# button30mm R3

<https://github.com/nealpalmer/UsbJoy>

Sheet: /  
File: button30mm\_rev3.kicad\_sch

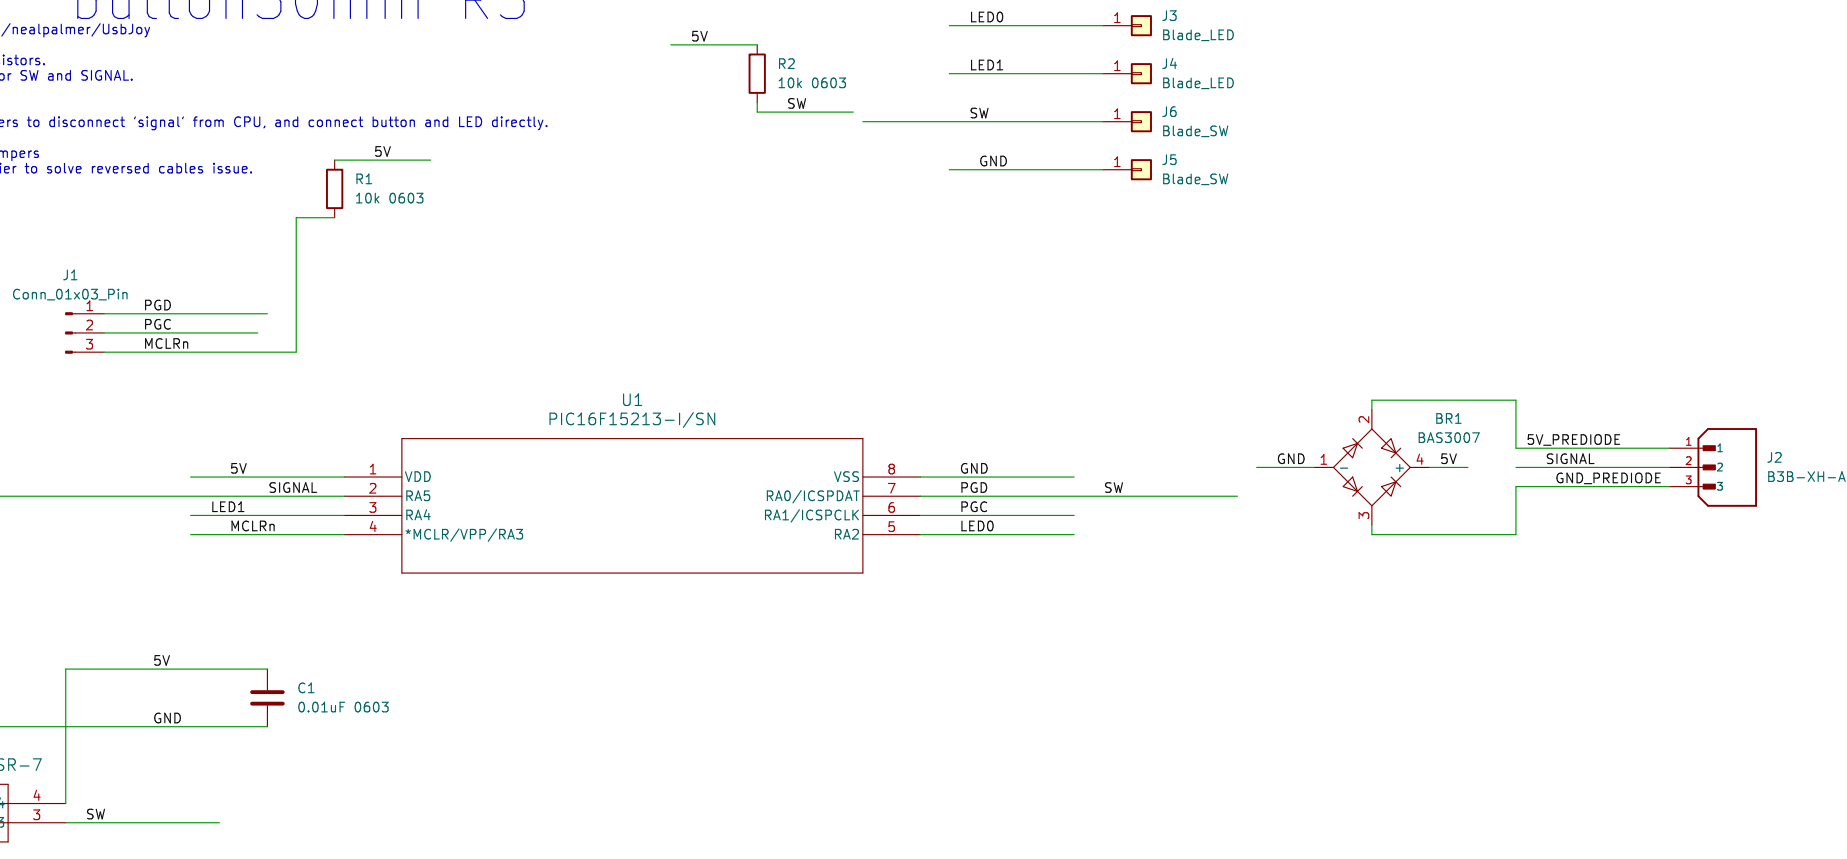
Rev2:

Added 2 pullup resistors.

Added ESD diode for SW and SIGNAL.

Enlarged SW slots.

Moved SW slots.

Added solder jumpers to disconnect 'signal' from CPU, and connect button and LED directly.

Rev3:

Removed solder jumpers

Added BridgeRectifier to solve reversed cables issue.
